RICHARDS RANCH ANNEXATION

RESPONSE TO COMMENTS ON THE 2022 DRAFT ENVIRONMENTAL IMPACT REPORT SCH NO. 2022020194

City of Santa Maria Community Development Department

SWCA Environmental Consultants

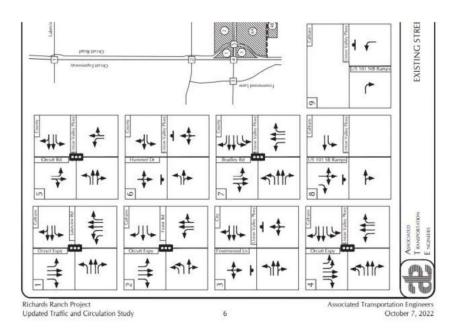
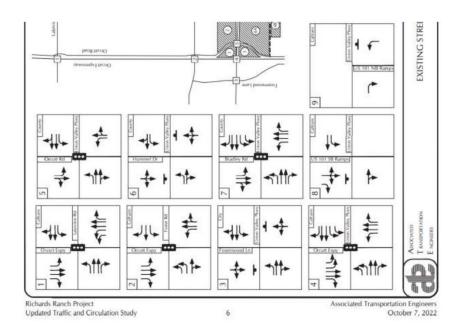
UVP needs to be improved to 4-lanes past Hummel Drive to the East as part of this Project, not at some time in the distant future (see below screen shot of Figure 18 in the EIR Appendix).

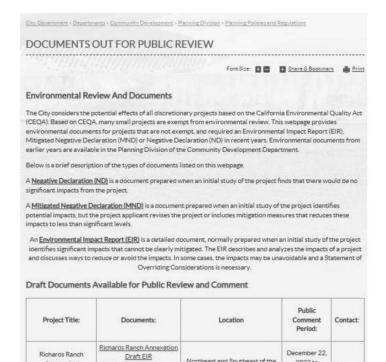
Also, Figure 2-3 (see below screen shots) does not appear to show a 2-acre area for open space/park uses. The C2 Commercial area along SR 135, South of UVP and West of Orcutt Road is listed as 2.33 acres. Nothing in the Park residential area in Figure 2-3 shows a 2-acre open space/park use. However, Alternate 2, Figure 5-2 does appear to have a nice layout for open space and park use.

As shown in the conceptual development plan (Chapter 2, Figure 2-3), the project would include several internal pocket park areas intended for use by future residents. The conceptual development plan also identifies an approximate 2-acre area to be dedicated to open space/park uses in the southwestern portion of the project site where the southern terminus of Orcutt Road meets SR 135. Given the conceptual nature of the plan, details of the proposed open space/park uses on the project site are unknown; however, it is anticipated that park spaces would be constructed concurrently with the associated residential development. Inclusion of these open space/park areas within the project site would contribute to the parkland that future residents could access.

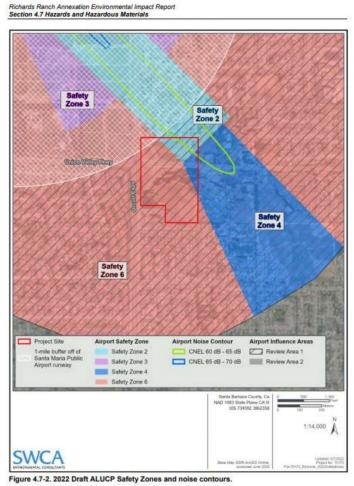
This seems like a risk that needs to be considered for the Richards Ranch Annexation Project due to current and future military activities at the Santa Maria Airport, especially the Airport Noise Contour in Figure 4.7-2 and the current 1993 ALUP Safety Area 2 in Figure 4.7-1

See below screen shot Figure 4.7-1 from p# 4.7-5, "1993 ALUP Safety Area 2 and Figure 4.7-2 from p# 4.7-7, "2022 Draft ALUCP Safety Zones and Noise Contours for the Santa Maria Public Airport.
